AS BUILT

CONTRACT NO.: ER28121

PLAN 1" =		ORANGE COUNTY PUBLIC FACILITIES AND RESOURCES DEPARTMENT	
		ANTONIO PARKWAY WILDLIFE UNDERCROSSING (WIDEN)	
		STA 307+10 TO 316+50 DRAINAGE PLAN D-3	
MARK	DATE	DESCRIPTION	
REVISIONS			
PREPARED UNDER RESPONSIBLE CHARGE OF:			
DESIGNED	DRAWN		CHECKED
SCALE AS SHOWN	DATE	DRAWING NO.	
			SHEET 13S OF 72

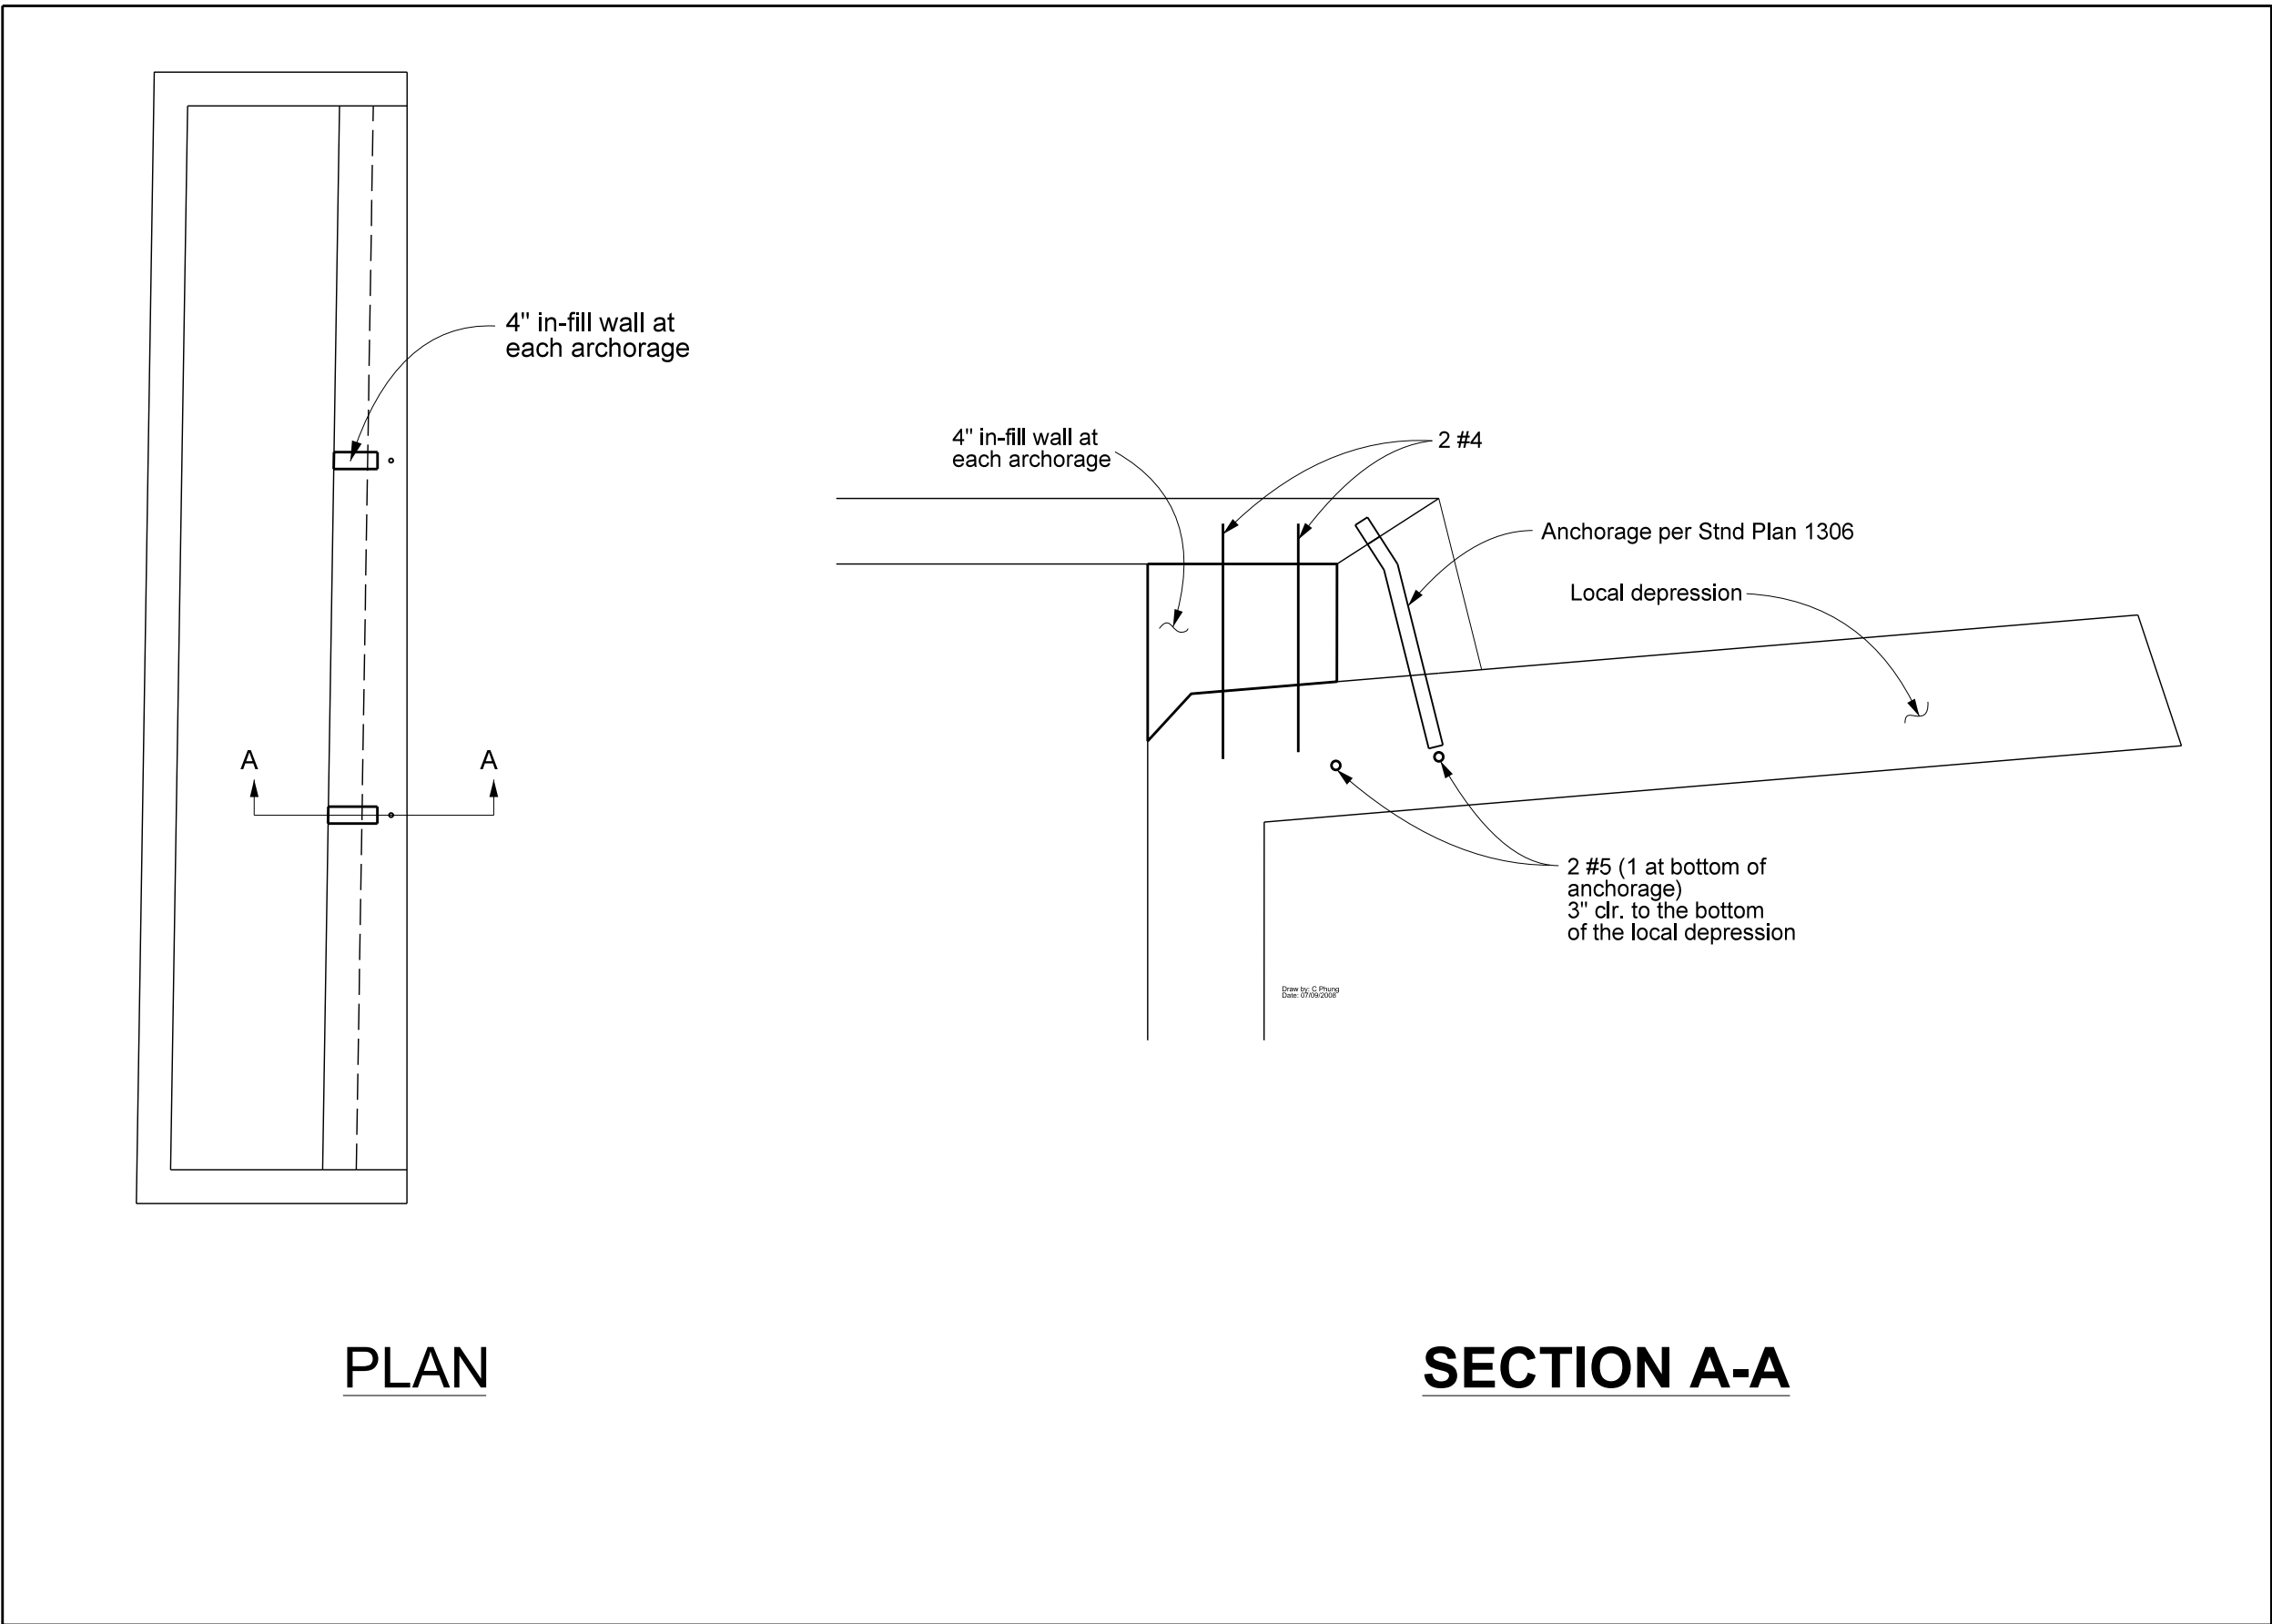
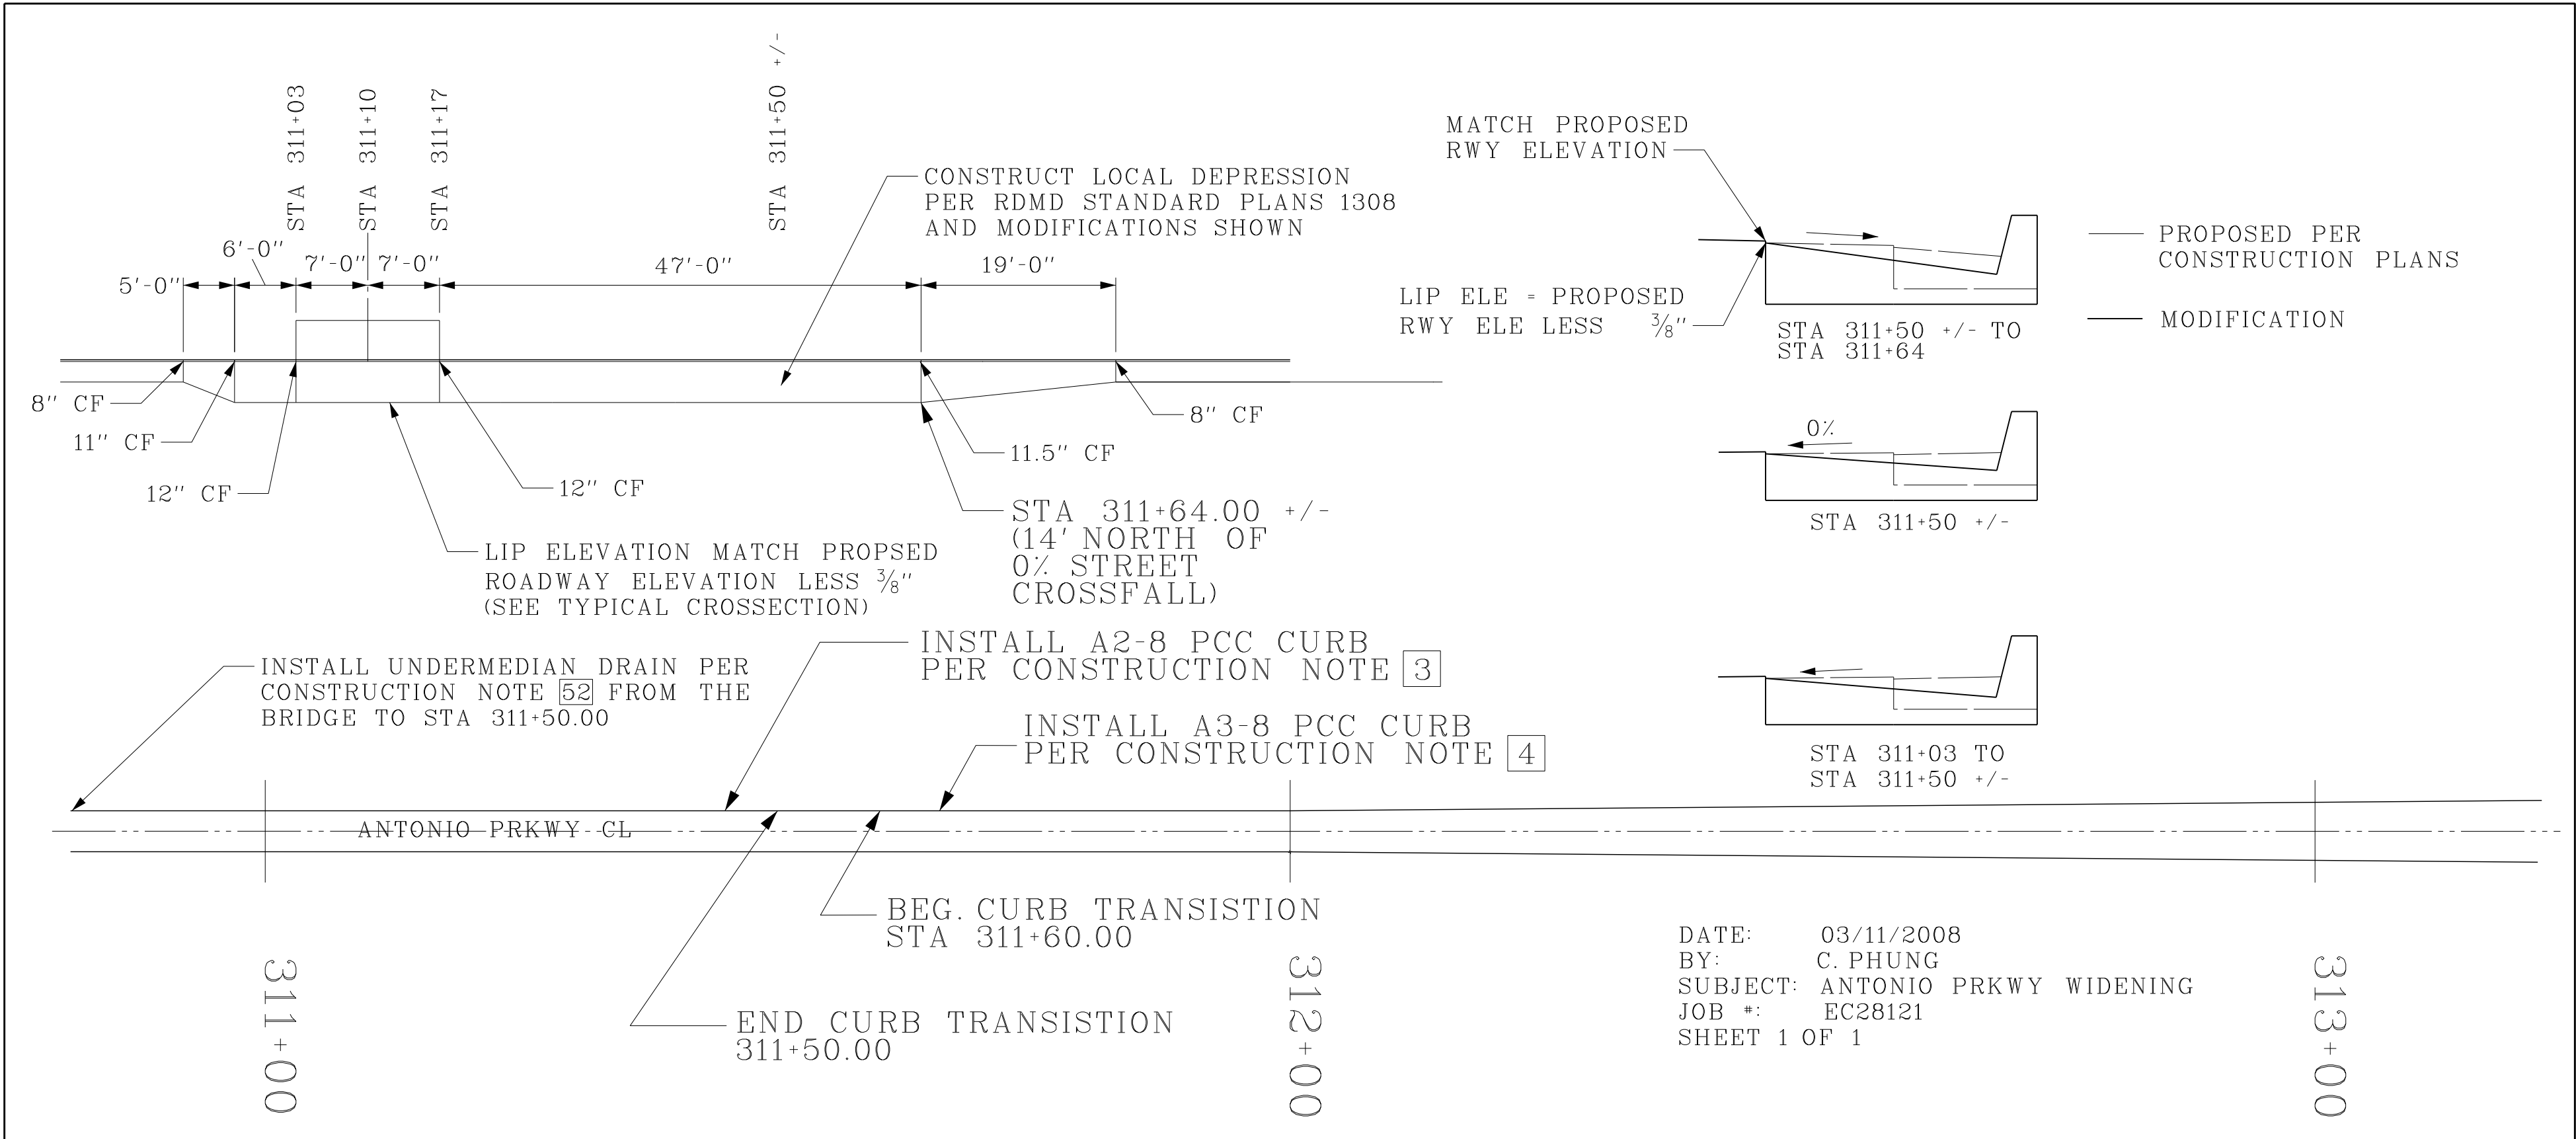
13S2 - LINE C & F PROFILES

13S3 - INLET IN-FILL WALL

13S1 - MODIFIED DRAIN INLET & UNDERMEDIAN DRAIN ADDITION

CORRECTION BY: MN
